Staff Report

To: Salt Lake City Planning Commission
From: Amanda Roman, Urban Designer
801-535-7660 or Amanda.Roman@slcgov.com
Date: December 13, 2023
Re: PLNPCM2023-00707 Edison Street Design Review

Design Review

PROPERTY ADDRESS: 220 & 250 S 200 E
PARCEL ID: 16-06-176-013-0000 & 16-06-176-028-0000
GENERAL PLAN: Downtown Plan
ZONING DISTRICT: D-1 Central Business District

Applicant's Request

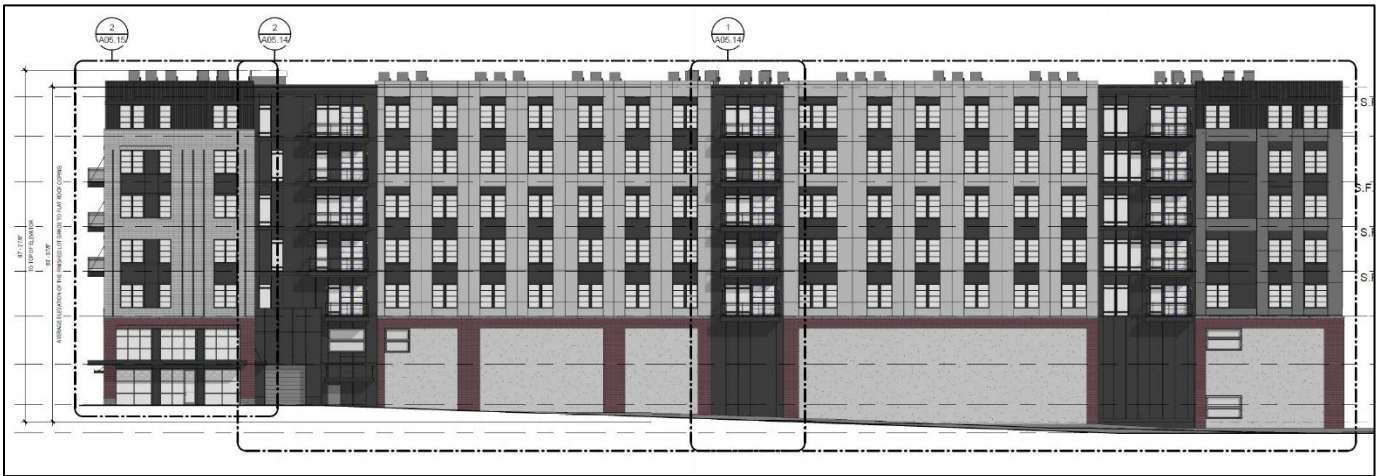
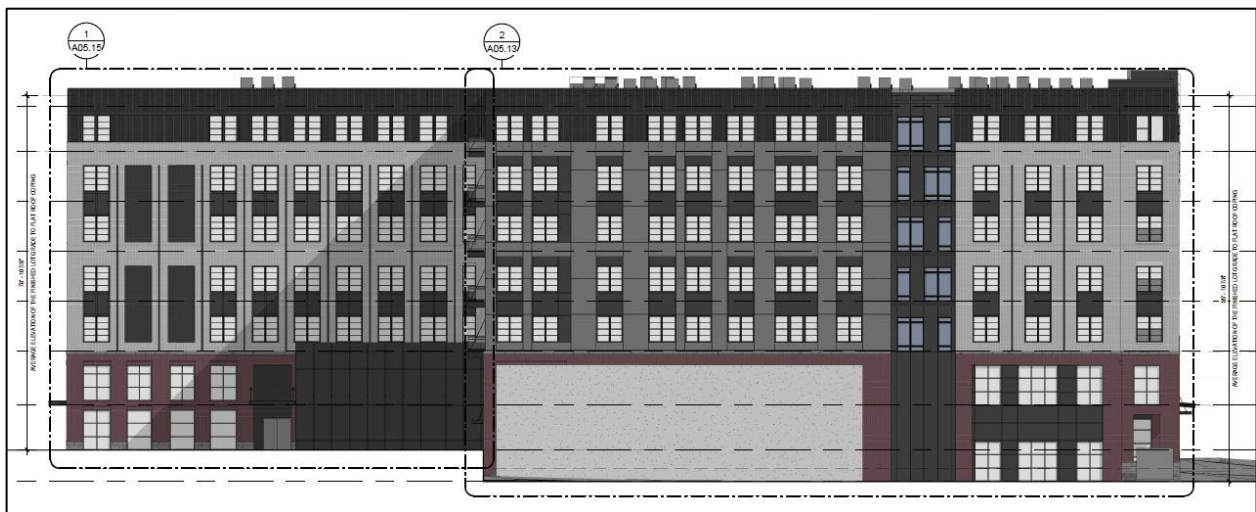
The applicant is requesting approval for a minimum building height of 78'6". The zoning ordinance defines building height as, "*The vertical distance from the average elevation of the finished lot grade at each face of the building, to the highest point of the coping of a flat roof; the deck line of a mansard roof, or the average height of the gable on a pitched gambrel, hip, or shed roof.*" The proposed building, with a flat roof design, averages about 83 feet in height, but due to the slight grade of the property, each of the four elevations has different average heights. The front and rear elevations facing 200 East and Edison Street have an average height of 83 feet. The northern building elevation, next to the midblock walkway, has an average height of approximately 79'6". The southern building elevation has an average height of 78'10", which is being rounded down to 78'6" to give the applicant some technical flexibility during the building permit process.

Eastern elevation (200 East) – average height of 83 feet

Northern elevation (midblock walkway) – average height of 79'6"

Western elevation (Edison Street) – average height of 83 feet

Southern elevation – average elevation of 78’6”

Diagram detailing the glazing on the front building elevation.

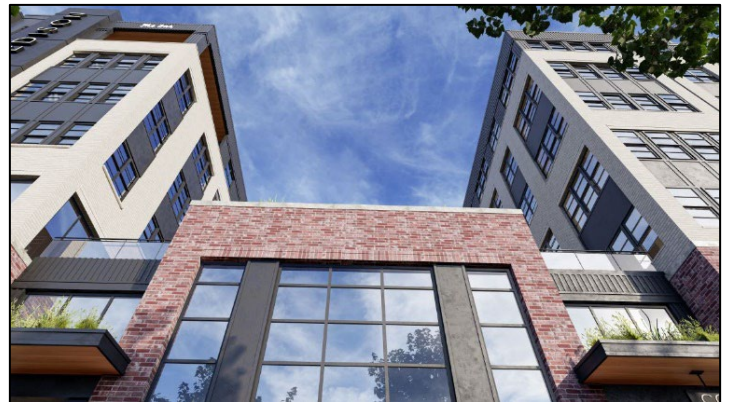
The ground floor comprises 90% active uses, including restaurants, a coffee shop, and a lobby along 200 East, as well as restaurants, food stalls, and a clubroom along the midblock walkway. All public spaces have high transparency, providing unobstructed views into the building from the public realm. The sections without glass include three stair towers, an elevator, an electrical room, and the fire riser room, strategically placed at the southern end or within the middle of the façade to separate the lobby and restaurant spaces. The first two floors along the midblock walkway and the portion with frontage on Edison Street are equally transparent. To mitigate the reduction in glazing, the proposal includes 100% durable building materials on all non-glass façade areas, exceeding the zones design standards that call for 70% durable materials on the ground floor and 50% on the upper floors.
